Attachment D: Internal Referral Comments

Development Engineering

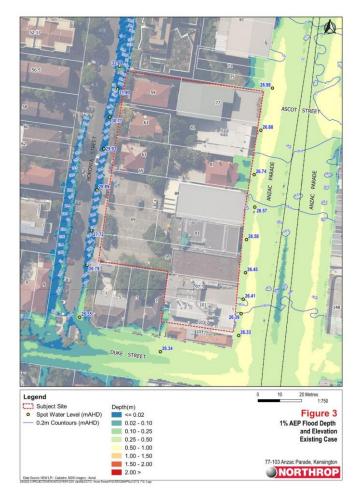
The assessing officer is advised that the subject development site lies adjacent to a flow path on Anzac Parade and a more minor flow path on Boronia Street with the adopted Kensington/Centennial Park Flood Study predicting the front of the site along the Anzac Parade frontage may be impacted by flooding with flood depths of 0.25-0.5m predicted in this area.

The applicant has submitted a Floodplain Management report by Northrop Pty Ltd which has further refined the flood model and increased resolution to a 1m grid (see plot at right).

They have also undertaken a pre and post development analysis to determine the impacts. As very little floodwaters actually entered the site pre-development due to the presence of brick facades and fences wall along the Anzac Parade frontage the new development will generally be replicating existing conditions in the sense flood waters will not generally enter the site thereby not significantly affecting flow paths or flood storage.

The floor levels of the proposed commercial tenancies along the Anzac Parade frontage have been designed at or above the level of the 1% AEP and are satisfactory and compliant with Council's requirements.

The minor flood way along Boronia Street is restricted to the road reserve and so will not impact on the proposed vehicle access, carpark and loading bay.

There are therefore no objections from a flooding perspective.
